Access Compliance Report Public Rights-of-Way (Curb Ramps)

Main Street: BULLARD_LN Cross Street: RED_HILL_AVE Location: N

ADA ID: RPRK220107121820 Ramp Type: Type 4 - Parallel Initial Pass/Fail: Pass Overall Compliance: No Severity Score: 4

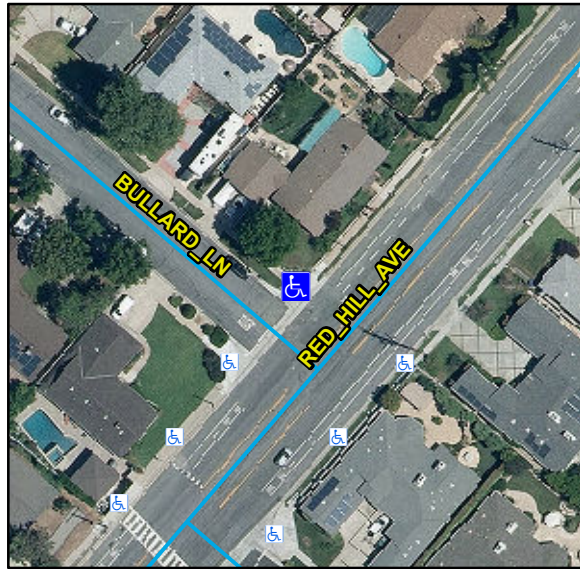
Compliance	Description	Data	Compliance	Description	Data
N/A	Ramp Length LT (in)	96	N/A	Ramp Length RT (in)	95
Yes	Ramp Width LT (in)	83	Yes	Ramp Width RT (in)	86
Yes	Ramp Run Slope LT (%)	6.9	Yes	Ramp Run Slope RT (%)	5.3
Yes	Ramp Cross Slope LT (%)	0.7	Yes	Ramp Cross Slope RT (%)	0.1
N/A	Landing Present	Yes	Yes	DWS Provided	Yes
N/A	Landing Length (in)	44	Yes	DWS Contrast	Yes
Yes	Landing Width (in)	48	Yes	DWS Length (in)	36
Yes	Landing Run Slope (%)	1.8	Yes	DWS Full Width	Yes
Yes	Landing Cross Slope (%)	0.3		DWS Offset Type	Single
N/A	Landing Movement Obstructed?	No	Yes	DWS Offset Left (in)	0
	Landing Movement Type	Curb	Yes	DWS Offset Right (in)	N/A
N/A	Landing Shared	No			
N/A	Clear Space	Yes			
N/A	Clear Space To Crosswalk (in)	48			
N/A	Marked Crosswalk 1	No	N/A	Marked Crosswalk 2	No
	Crossing 1 Direction	SW		Crossing 2 Direction	SE
N/A	Marked Crosswalk 1 Width (in)	N/A		Marked Crosswalk 2 Width (in)	N/A

N/A	Ramp Inside Crosswalk 1	N/A	N/A	Ramp Inside Crosswalk 2	N/A
	Crossing 1 Slope (%)	2.5		Crossing 2 Slope (%)	6.5
	Crossing 1 Cross Slope (%)	0.6		Crossing 2 Cross Slope (%)	4
Yes	Gutter Ponding	No	Yes	Curb Slope	5.1
Yes	Gutter Lip Height (in)	0		Road Run Slope (%)	1.6
Yes	Gutter Run Slope (%)	4.1		Road Cross Slope (%)	3.6
No	Gutter Cross Slope (%)	2.3	Yes	Perpendicular Joint Present	Yes
Yes	Overall Surface Condition	Acceptable			
	Cross Gutter Present?	Yes		Spandrel Present?	Yes
	Replace Cross Gutter?	No		Replace Spandrel?	No

Remove & Replace Landing. Remove & Replace Gutter.

R304.2.1, R304.5.3, STD 1115
